Access Compliance Report

Public Rights-of-Way

(Pedestrian Signals)

Intersection ID: N/A	Main Street:	Cross Street: N/A	Location: N/A
ADA ID: FEEEA1A8648F	Signal Type: One Push Button-Non APS	Overall Compliance: No	Severity Score: BTN 1: N/A BTN 2: N/A No BTN: N/A
Codes/Mitigation Info/Possible Solution		Field Measurements/Component Compliance

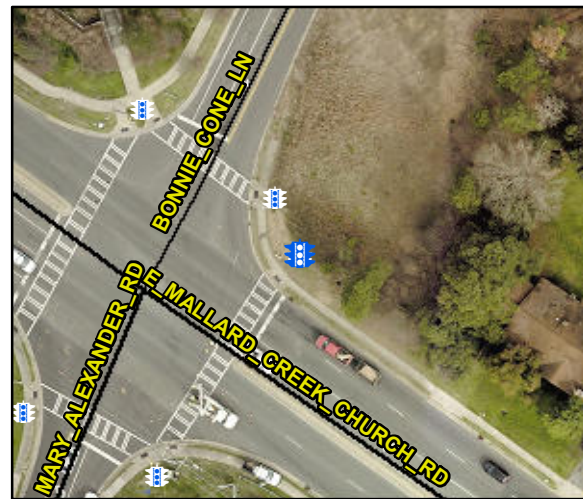
Possible Solutions: Replace Signal Push Button With APS Button on New Post. Remove & Relocate Sign.

PROW/ADA: TMUTCD 4e.08, R404.2, R404.7.3, R404.7.2

N/A	B 1 Clear Xing Direction?	Yes	N/A	B 2 Clear Xing Direction?	N/A
	B 1 Crossing Direction	To SW		B 2 Crossing Direction	N/A
Yes	B 1 DistanceTo XWalk (in)	26.0	N/A	B 2 DistanceTo XWalk (in)	N/A
No	B 1 DistanceTo Curb (in)	108.0	N/A	B 2 DistanceTo Curb (in)	N/A
Yes	B 1 Diameter (in)	2.0	N/A	B 2 Diameter (in)	N/A
